STAFF REPORT: NOVEMBER 12, 2025 MEETING

APPLICATION NUMBER: HDC2025-00642

ADDRESS: 2725 W. BOSTON

SCOPE: MASONRY WORK AND BUILDING REHABILITATION, INCLUDING NEW ROOFS (NOT CLAY TILES), DOORS, AND LIGHTING.

2725 W Boston, west side of east tower, from courtyard. Contrasting brick accents, dentil molding, tile insets, and clay tile roof are shown. Copper gutter appears pale green and has a dark downspout. All gutters and downspouts are proposed to be replaced.

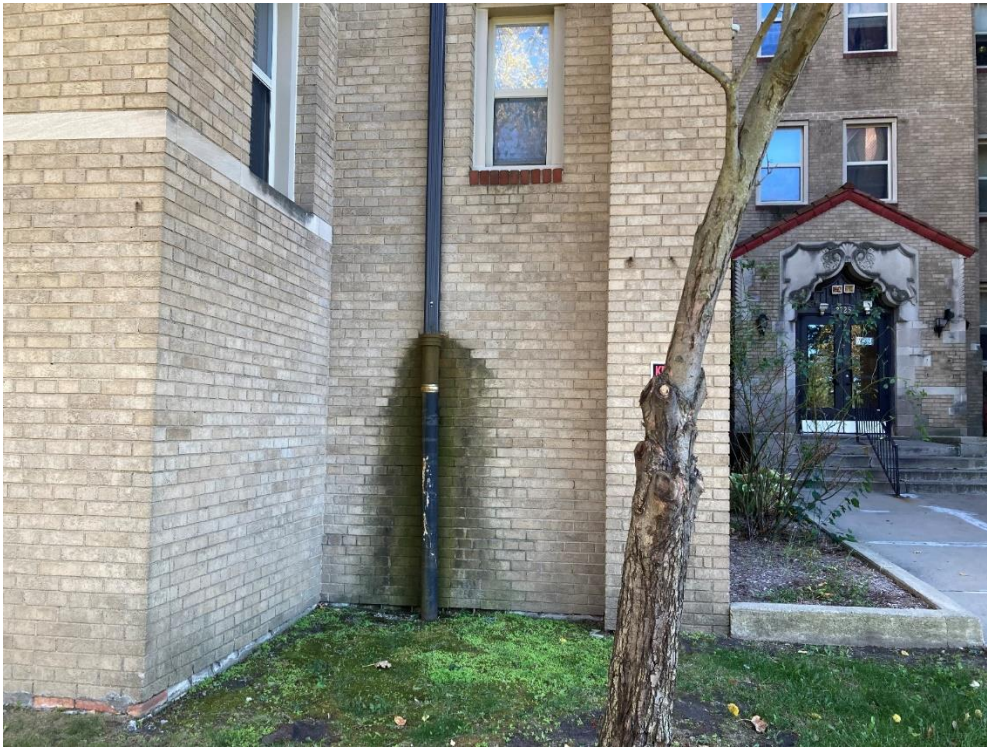
- Based on the gutters that remain on the north/primary side of the building, it appears that copper was likely used for gutters and downspouts on this building historically, or at least on the primary facade. Copper gutters and downspouts would have been prominent initially, but they would have aged to a pale green over time (as they are now), quietly complementing the red roof tiles and other Spanish Revival features. Although copper gutters remain on the building's north side today, by 2006 when the district was designated, copper downspouts had been replaced with tan aluminum downspouts on this side.

- The Secretary of the Interior's Standards for Rehabilitation require that historic materials, like extant copper gutters, are repaired before being replaced. If the copper gutters are beyond repair, as per the Standards, they should be replaced in kind, and copper downspouts would best complement the copper gutters.

- If copper gutters and downspouts for the building's north side are not feasible and a substitute material is required, aluminum gutters and downspouts in brown or a shade of green would meet Standard 6 better than the proposed black, because brown or green would be closer to the historic material's visual qualities.

- Staff will review and approve gutter and downspout colors. No historic copper gutters can be replaced unless in kind.
- Windows on proposed steel panel-style replacement doors, and colors for the doors (for corner doors, side doors, and roof doors) must be submitted to staff for review and approval.

Existing non-historic wall sconces flanking the main entrance doors (left) and proposed LED replacements (right).

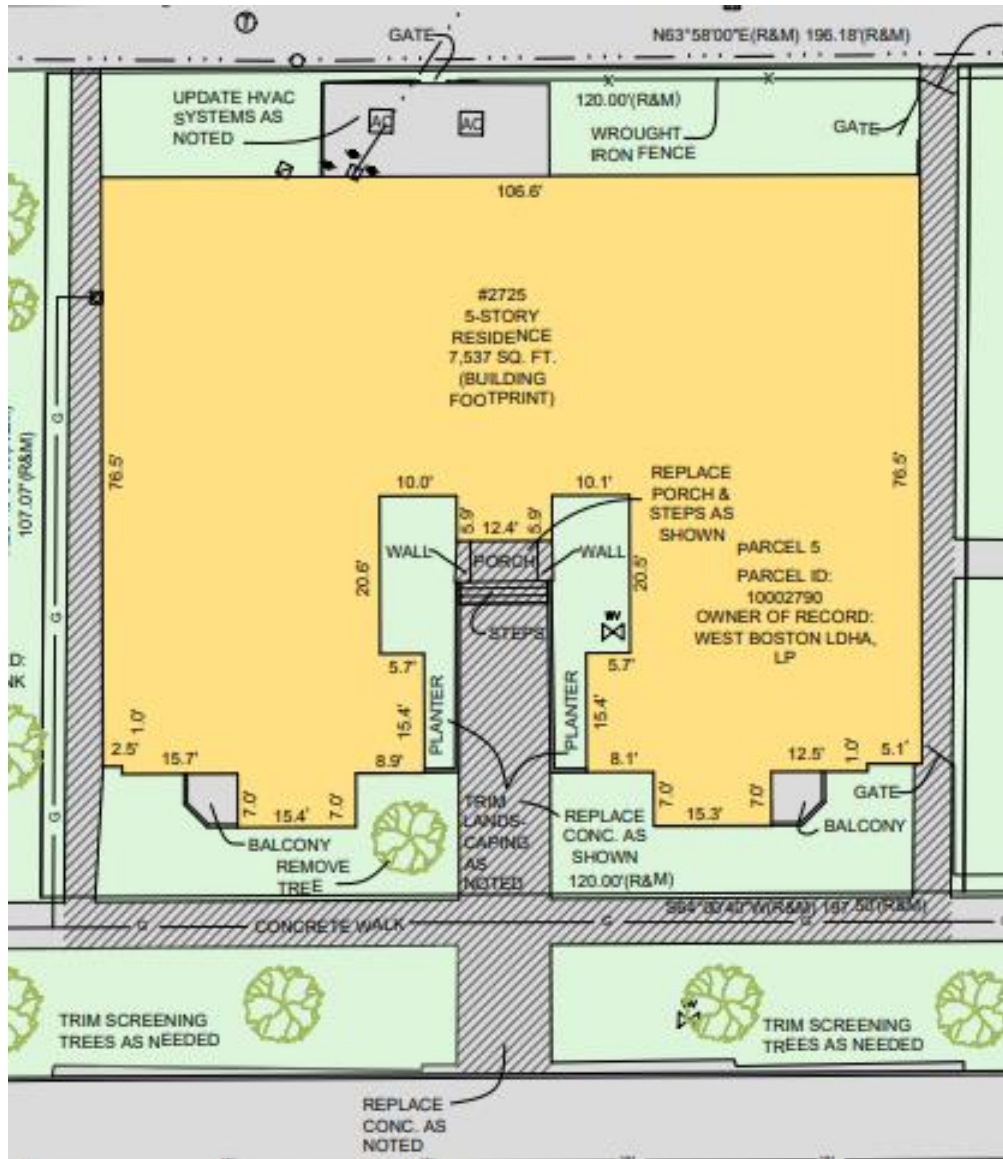
- Regarding the design of the proposed fixtures, the lanterns flanking the front, main doors seem to staff to meet the Standards in terms of compatibility with the building's architectural features, whereas the security lights, in staff's opinion, do not. A security light that is more compatible with the building's architectural features should be specified.

- The applicant will submit for staff review and approval product specs/ cut sheets for a security light that is more compatible with the historic building's architectural features.
